**CITY OF OAKLAND**  
**AGENDA REPORT**

RE: Supplemental Report On The Measure DD Lake Merritt Projects And  
Recommendations On Potential Alternatives For Action

ALTERNATIVE PLAN PROPOSED BY THE COMMUNITY  
NOT TO SCALE

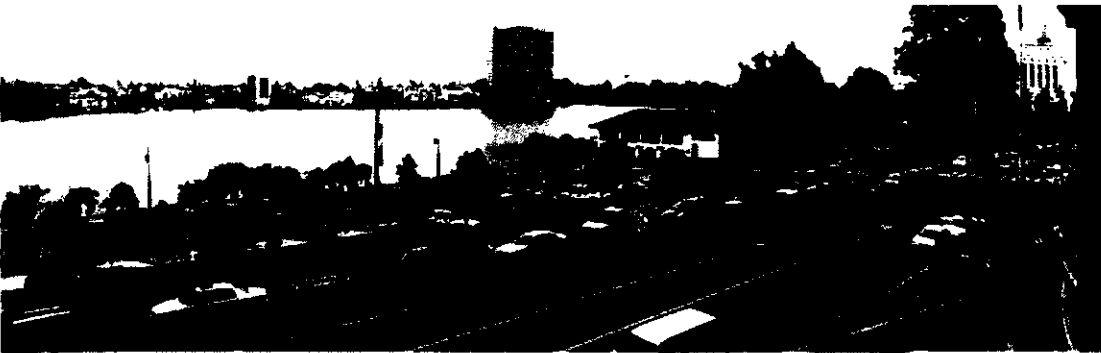
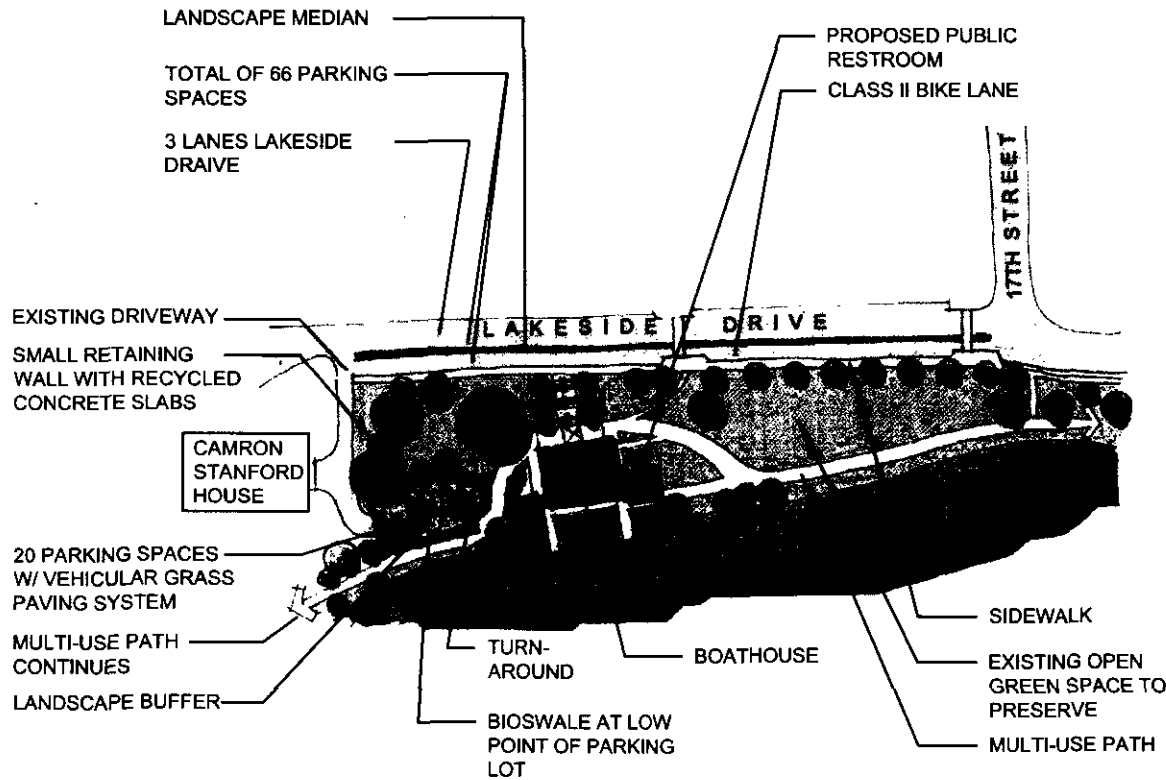
The neighbors' plan emphasizes preservation of the turf area north of the Boathouse. All parking north of the Boathouse is eliminated. Parking is added along a new median island in Lakeside Drive, and the existing parking lot south of the Boathouse is enlarged.

- Green space in the north lawn area is preserved.
- Two trees on north side are preserved and one more tree on the south side must be removed, for a net gain of one tree.
- Reducing Lakeside Drive to two lanes during non-peak hours should help calm traffic.

- The addition of a median island and a bike lane requires moving the curb and sidewalk ten to twelve feet into the park. This change significantly reduces green area and steepens the slope towards the building.

- Widening the street will require new curb, gutter and sidewalk, relocation of streetlights and conduits, reconstruction of street grades to ensure drainage, and relocation of storm drain inlets. Steeper slopes may require retaining walls. This work is very expensive. Even considering the savings from replacing the proposed north parking lot with turf, the net extra expense is estimated to be approximately \$150,000.

- The proposed south parking lot is very close to the Boathouse and does not provide an appropriate landscaped setting for the historic building.
- The proposed south parking lot is very close to the multi-use path, squeezing the path into sharper turns and visually intruding into the experience of the path users.

- The proposed south parking lot is in the view of the neighbors at 1515 Lakeside, and reduces the green lawn area on this side of the Boathouse.
- The proposed south parking lot is a dead-end design, and does not provide convenient circulation like the proposed north parking lot would.

- The bio-swale at the north lawn is eliminated, causing street storm drain water to continue flowing untreated into the Lake.
- The proposed reinforced grass paving at the new south parking lot does not have a good track record for lots that receive normal to heavy use. The City's design using concrete turf cells filled with permeable decomposed granite would be more appropriate.

- The delivery entrance and kitchen, located on the north side of the building, is not well-served by the south parking lot.
- There is no provision for covered storage or pickup of the garbage and recycling bins.

- Restroom is proposed to remain in its existing location, detracting from the historic building, providing a hidden area for unsavory activity, and creating an awkward and unpleasant approach to the proposed café entrance.

Staff believes that the advantages of the neighbors' design are outweighed by the disadvantages.
